Village of Bayside 9075 N Regent Road Architectural Review Committee Meeting September 16, 2024 Village Board Room 5:00pm

## ARCHITECTURAL REVIEW COMMITTEE AGENDA

PROJECT/SITE OWNER:	PROJECT SUMMARY:
White Oaks / Katz Properties	Monument sign 14 1/2' wide X 10' high
PROJECT ADDRESS: 9001 N Port Washington

#### **VILLAGE CODE REVIEW**

#### KATZ MONUMENT SIGN RESUBMITTAL

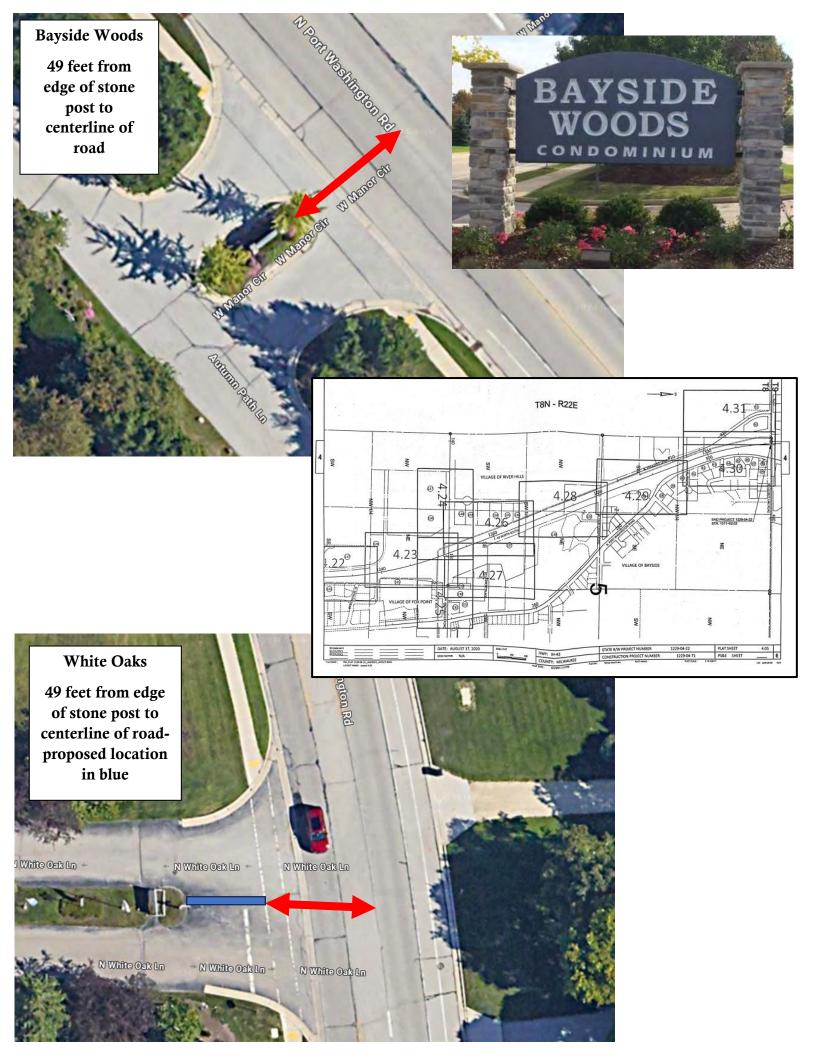
- 1. The monument sign does not comply with sign ordinance Chapter 116 Signs.
- 2. The proposed sign is ten feet high and fourteen and a half feet wide
- 3. On their application they state that the sign is four feet by eight feet. There is a discrepancy from the application and drawing submitted.
- 4. Per 116-6 (7) signs in business districts "Freestanding signs shall not exceed eight feet in height above normal grade and eight feet in maximum width."
- 5. The board always considers the aesthetics of the signs.

PLAT OF SURVEY

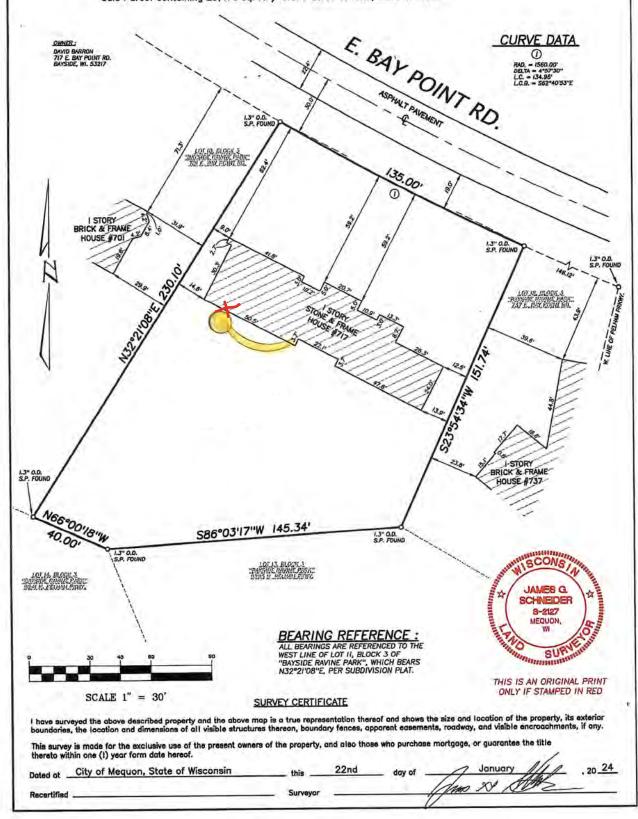
Building Inspection does not have any issues with this submittal.

This review is only for ARC and not for permitting. They have included landscaping to screen the ramp

# PROPOSED SITE PLAN

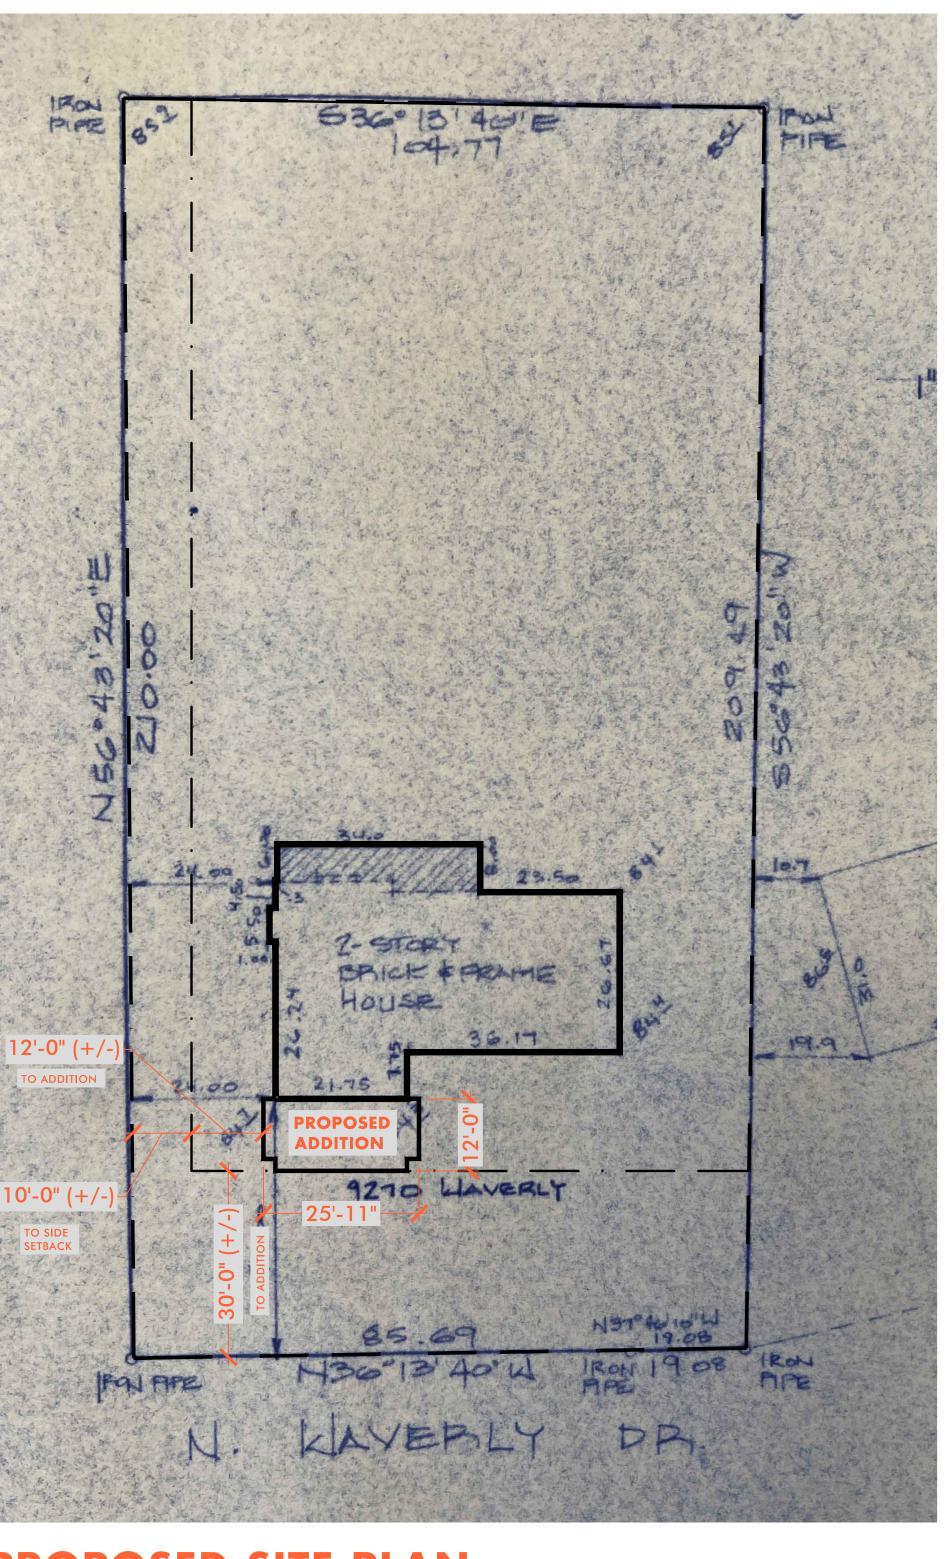
A current survey was provided, the proposed addition meets the setbacks.

- 1. The proposed submittal meets the prescribed ordinances.
- 2. The application has good description of proposed material and colors.
- 3. The board always considers the aesthetics of the project.
- 4. This review is only for ARC and not a building permit.

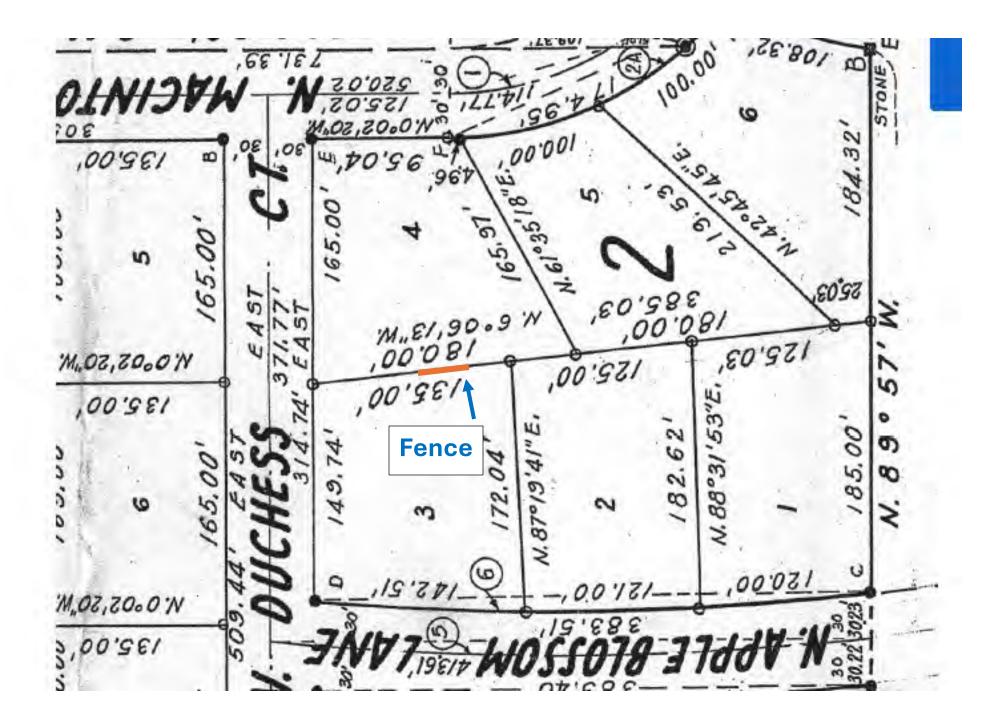
- 1. A current survey was provided.
- 2. They did not indicate the height of the fence. They must abide by the ordinance and not exceed the 30 length of a solid fence.
- 3. The board always considers matching fences with neighboring fences.

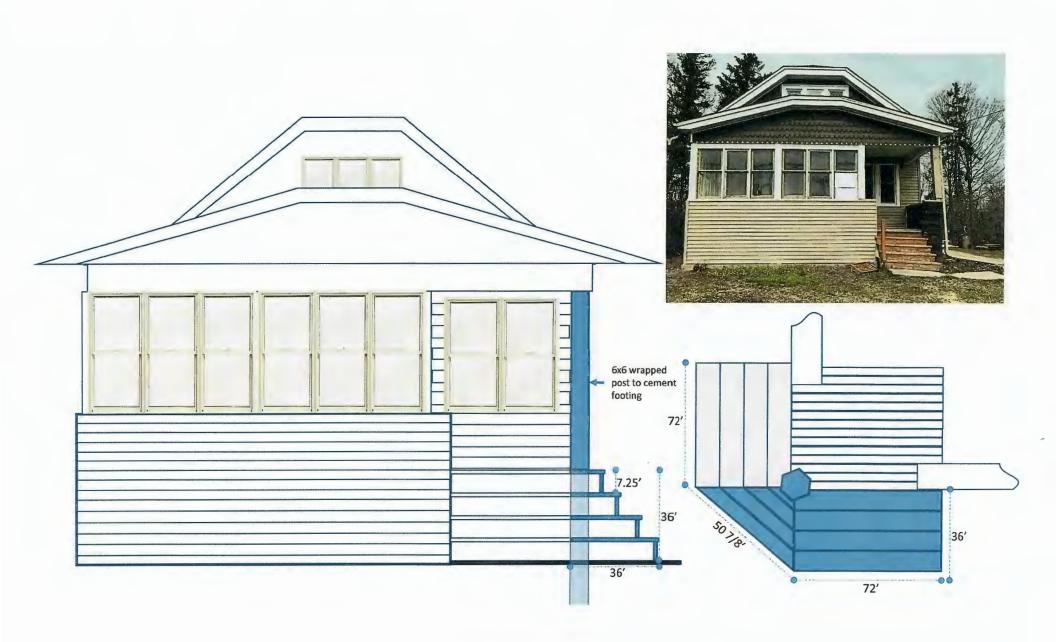
- 1. They have gone to BZA and got approval for the stairs on the side of the home that contradict the setbacks as well signed a right of privilege agreement
- 2. Because of the BZA approval there are no issues with this submittal
- 3. This review is not for permitting.

PLAT OF SURVEY

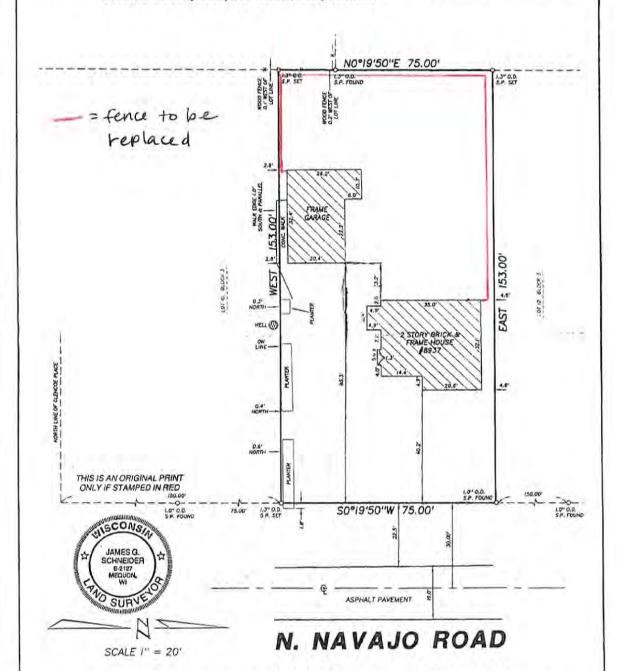
- 1. A current survey was provided.
- 2. In the pictures submitted they show a solid fence, which appears to be over the allowable lineal footage per the ordinance. They state that they are replacing their fence with an open design picket style. This needs to be clarified.
- 3. The board always considers matching fences with neighboring fences.
